Access Compliance Report

Public Rights-of-Way

Intersection ID: 31799	Main Street: ALMOND_RD	Cross Street: TRIPLE_J_CT	Location:	N
ADA ID: 3E9EDF35A632	Ramp Type: Perp	Initial Pass/Fail: Fail	Overall Compliance: No	Severity Score: 25

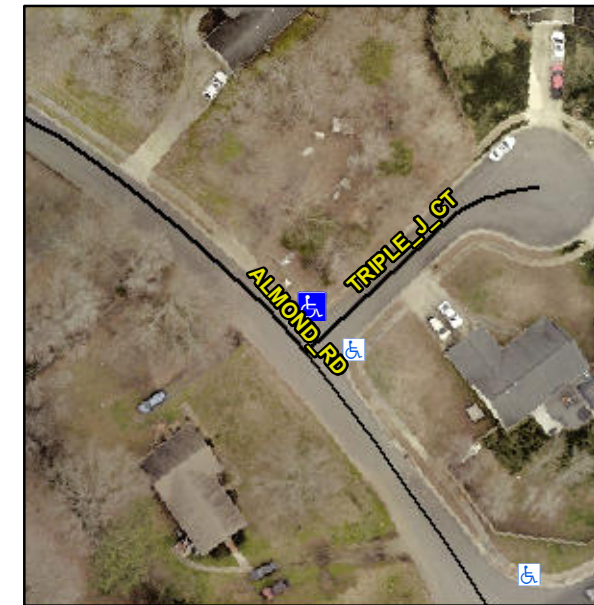
Not Found, R304.2.2, R304.5.3

Compliance	Description	Data	Compliance	Description	Data
N/A	Ramp Length (in)	69.0	No	Ramp Slope (%)	9.1
Yes	Ramp Width (in)	48.0	No	Ramp XSlope (%)	6.6
N/A	Flare Type LT	N/A	N/A	Flare Type RT	N/A
N/A	Flare Slope LT (%)	N/A	N/A	Flare Slope RT (%)	N/A
N/A	Flare Traversable LT?	N/A	N/A	Flare Traversable RT?	N/A
N/A	Landing Length (in)	N/A	N/A	DWS Provided?	N/A
N/A	Landing Width (in)	N/A	N/A	DWS Contrast?	N/A
N/A	Landing Slope (%)	N/A	N/A	DWS Length (in)	N/A
N/A	Landing X Slope (%)	N/A	N/A	DWS Full Width?	N/A
N/A	Landing Curb? (Y/N)	N/A	N/A	DWS Offset (in)	N/A
N/A	Shared Landing?	N/A			
N/A	Gutter Ponding?	N/A	N/A	Gutter Slope (%)	N/A
N/A	Gutter Lip Ht (in)	1.0	N/A	Gutter X Slope (%)	N/A
N/A	Painted X Walk1?	No	N/A	Painted X Walk2?	N/A
	X Walk 1 Direction	To SE		X Walk 2 Direction	N/A
N/A	X Walk 1 Width (in)	N/A	N/A	X Walk 2 Width (in)	N/A
	X Walk 1 Slope (%)	1.7		X Walk 2 Slope (%)	N/A
	X Walk 1 X Slope (%)	8.1		X Walk 2 X Slope (%)	N/A

Remove & Replace Entire Ramp.
